DART SERVICE INSTRUCTION

TO AMEND INSTALLATION INSTRUCTIONS IIN-D407-781-2 REV. A OR LATER APPROVED REVISION
AND INSTRUCTIONS FOR CONTINUED AIRWORTHINESS ICA-D407-781 REV. 3 OR LATER REVISION

In some aircraft, the top portion of the D206-781-041 Baggage Compartment Wall Protector Kit cannot be installed as indicated in IIN-D407-781-2. The purpose of this DSI is to provide an alternate mounting method to fasten the top portion of the D206-781-041 Baggage Compartment Wall Protector Kit.

SHOP COPY
RETURN TO
ENGINEERING
UNCONTROLLED COPY
SUBJECT TO AMENDMENT
WITHOUT NOTICE
WORK ORDER
NO. 155495 M.C.S.
170118

FIGURE 1 - D3879-1 BAGGAGE COMPARTMENT WALL PROTECTOR - ALTERNATE INSTALLATION

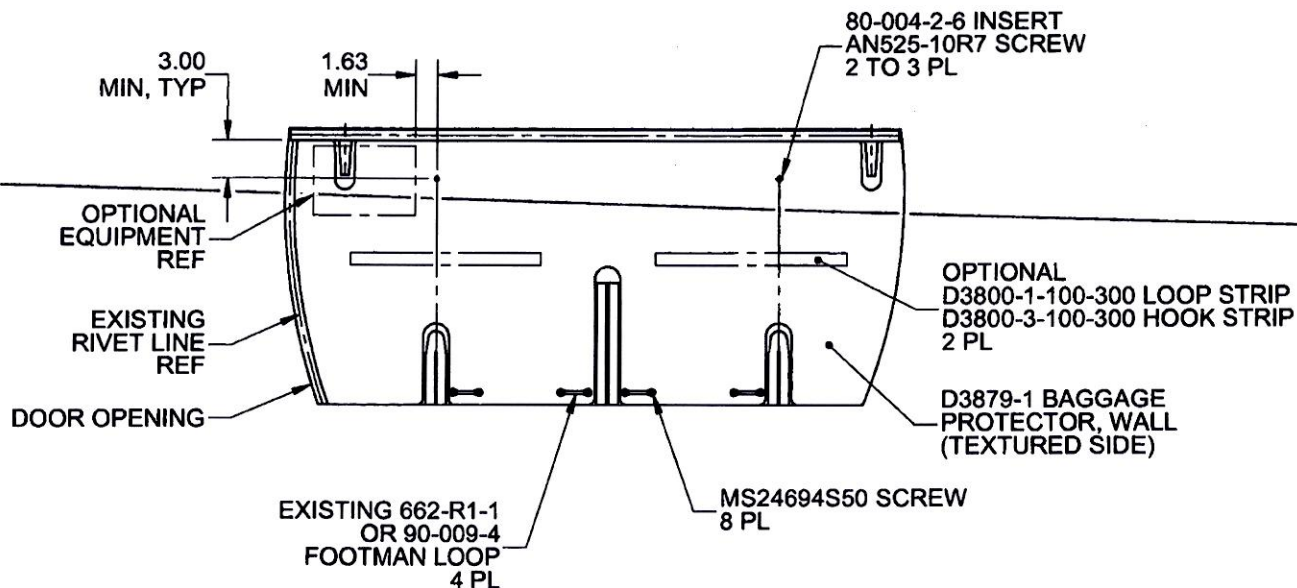
It is acceptable to replace qty(2) D3930-1 Clips with qty(2) 80-004-2-6 Inserts. Locate and mark location of the two attachment holes on the baggage compartment wall as shown in Figure 1 of this service instruction. Install 80-004-2-6 Inserts at the marked locations in accordance with Section 3-2-12 of BHT-206-SRM-1. It is acceptable to trim the wall protectors to accommodate optional equipment or transfer attachment holes to the wall protector and install the optional equipment on top of the wall protector with longer fasteners.

Amend the D206-781-041 Baggage Compartment Wall Protector Kit parts list as follows:

Qty -061	Qty -031	Qty -041	Part Number	Description
X			D206-781-061	BAGGAGE COMPARTMENT PROTECTOR KIT (FLOOR AND WALL)
1	X		D206-781-031	BAGGAGE COMPARTMENT FLOOR PROTECTOR KIT
1		X	D206-781-041	BAGGAGE COMPARTMENT WALL PROTECTOR KIT
		2	AN525-10R7	SCREW
		2	80-004-2-6	INSERT
